# Response to "Powering Daintree" Sunverge/ARENA 2018

Australian Tropical Research Foundation

29May 2018

*Map 1* Map of Option 1 from Sunverge – (modified with explanatory labels)

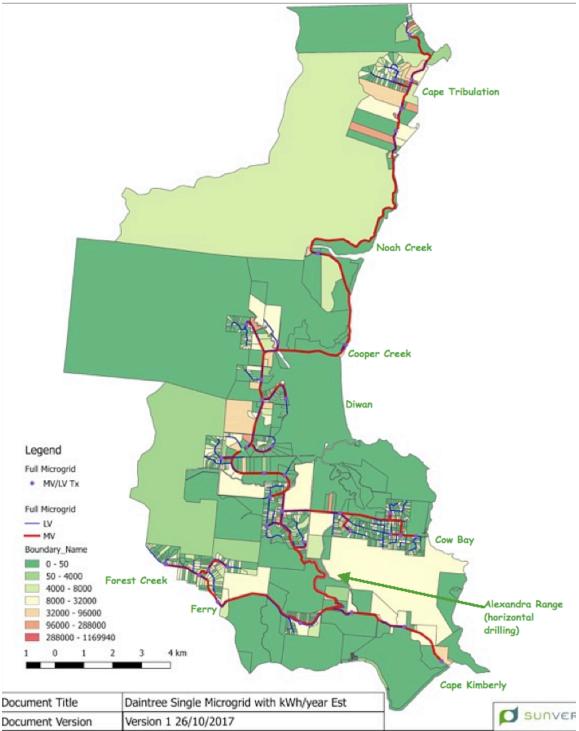
This is a considerable body of work undertaken locally, offering a more detailed insight into possible demand. The distribution of distances from the road for both private and commercial properties has been measured in all precincts of the Daintree Lowlands.

The Sunverge Report does not attempt to assess either of these key issues. It makes no mention of these additional householder/business cost issue. They will have a damping effect on uptake – the report assumes a high level of acceptance of connection on unsubstantiated grounds.

This proposal suggests a single (we assume 20KV high voltage spine) from the ferry to Cape Tribulation and multiple low voltage feeders (4KV). Proposed Solar farms – Forest Creek, Cape Kimberly, Cow Bay (2 solar 'farms'), none at Cape Tribulation. These seem to be a bit of an afterthought.

Large fuel cells at Cape Tribulation – using surplus electricity for hydrogen production. A major issue is that hydrogen has a low energy density – you need a lot of hydrogen and a very big fuel cell to balance loads – Tesla-style batteries are better (or flow cell batteries). Plus, unless hydrogen is liquefied, you would need a very large storage capacity.

Map 2 Sunverge map forOption 2 (modified with explanatory labels)

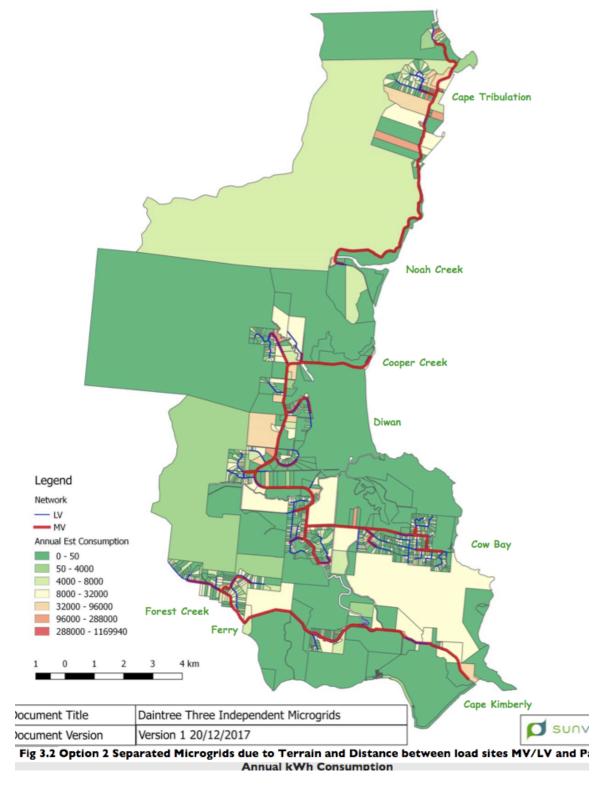
This option avoids the possibility of drilling through the Alexandra Range, but would not be able to service the Telstra relay tower on the range.

Option 1 suggested the use of extensive solar generation from the Kimberley region (as Cape Tribulation has lower solar potential), as well as load balancing (assuming the existence of "the expected two resorts (at cape Tribulation) which are awaiting grid power". The identity of these proposed resorts are not specified, and Coconut Beach resort (which would have been a major potential consumer) is highly unlikely to re-open). Option 2 would eliminate this.

There is also the assumption of high A/C use, which from the perspective of long-term residents in the area is quite unnecessary, as the presence of the main range tends to result in cool evening conditions (cold air flowing down to the coast). So far, none of the existing Cape Tribulation resorts (Ferntree. PK's and Beach House) have attempted to regulate A/C use by guests (fitting tag switches, for example). Building insulation is poor https://www.greenexpressdirect.com/pdf/hotelroomsystememail.pdf

Having a spur line from Cape Tribulation to service Noah Valley Farms (whose power levels can easily be supplied by solar - or even hydro) does not make economic sense. Noah Beach campground does not require electricity (it is a "cold water" campground).

*Map 3* Sunverge map of Option 3 (with added explanatory labels)

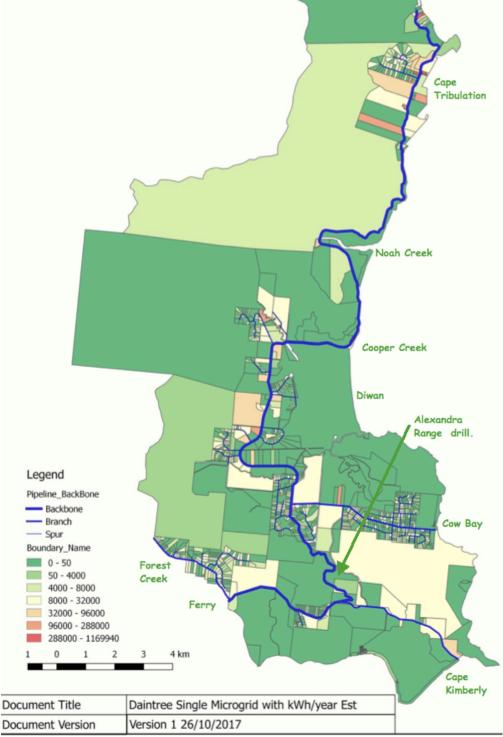
The rationale for this option was the "low cost, high reliability and simplicity of installing underground polyethylene gas pipeline networks". (it would still, presumably, require a directional drill through the Alexandra range).

Map 4 Sunverge map for Option 4 (with added explanatory labels)

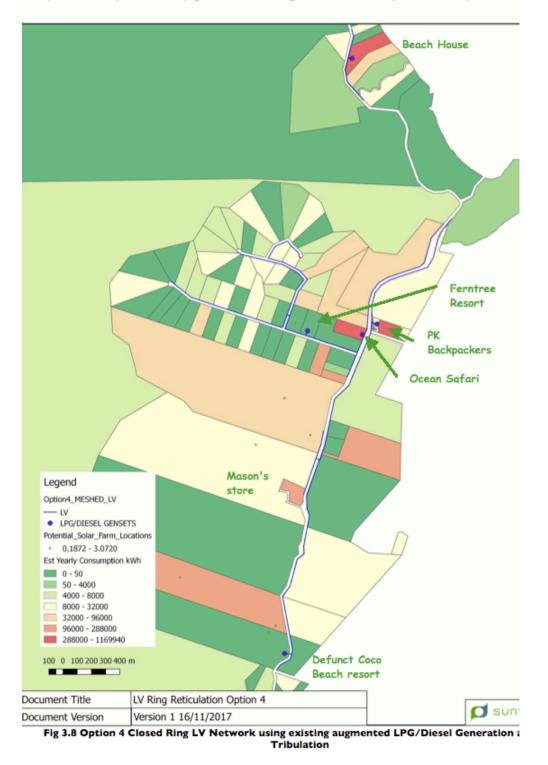
This option addresses Cape Tribulation alone – as the Study suggests that "Cape Tribulation has nearly 50% of the anticipated load, but only 15% of the expected customers" The study assumes that there is no access to solar at Cape Tribulation – which is incorrect.

The Study's associated maps indicate a poor level of assessment of energy resources and potential demands in this area. Coconut Beach Resort (now abandoned) is shown as a potential generating node!
